Model: GF10 Date:			ate: 31-Mar-	99	No.: 1
Modified Article: Paper Pick-up Sensor			Prepared by: K. Moriizumi		
From: GTSS Field I	nformation Dept				
Reason for	☐ Parts catalog correction	☐ Vendor o	change	☐ To r	neet standards
Modification: ☐ To facilitate assembly ☐ To im		⊠ To impro	ove reliability	()
	☐ Part standardization	Other

Modification Bulletin

toloododi 10	1101 00								
Model: GF10				Date: 31-Mar-99		No:	MG02500	05a	
MB Correction The items in bo		ve been correcte	ed or add	ded.					
Modified Articl	e: ADF Unit			Prepared by: K. Moriizumi					
From: Technica	l Services Dept	.,GTS Division							
Reason for Modification:	☐ To faci	catalog correction litate assembly andardization		•	ange e reliabilit	I — /	o meet s	tandards	
Model:	0-1S 🗒 GI	F10-2 F10-2S F10Better							
Old part	New part	Descrip	otion		Qtv	Int	Page	Index	Note

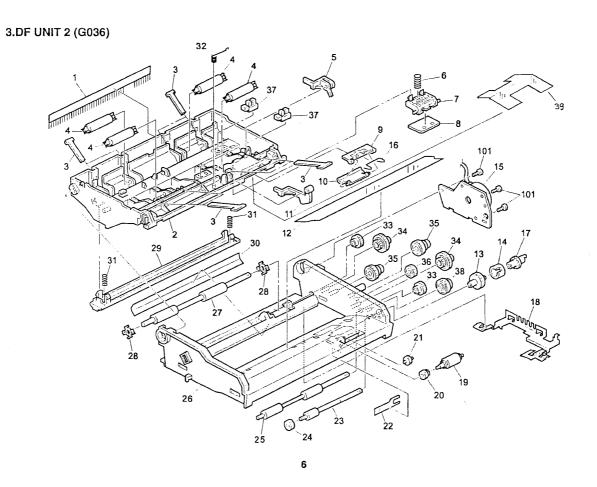
Old part	New part	Description	Qty	Int	Page	Index	Note
number	number						
G0253004	−G0253047	Actuator – Paper Pick-up Sensor	1	X/X	17	23	1
	−G0253048	Shaft – Paper Pick-up Sensor	1	X/X			1
G0253026	G0253049	Spring – Paper Pick-up Sensor	1	X/X	17	22	1

Note: The interchangeability of these parts as a combination is "X/O". For example, all parts need to be replaced even if only G0253026 (spring) is replaced.

Cover - Ground Plate

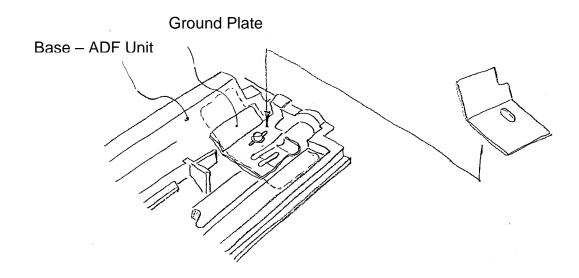
The Grounding Plate has been added to reduce the noise that was being generated at the contact point between the roller and ADF base.

This modification was implemented from the first lot of April 1999 mass-production.

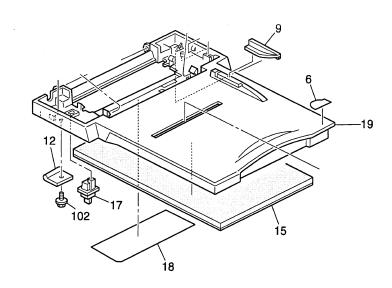
Old part	New part	Description	Q'ty	Int	Page	Index	Note
number	number						
(GF10-2)							
-	G0272406	Shading Plate – Front			5	18	
-	G0272401	Platen Cover			5	19
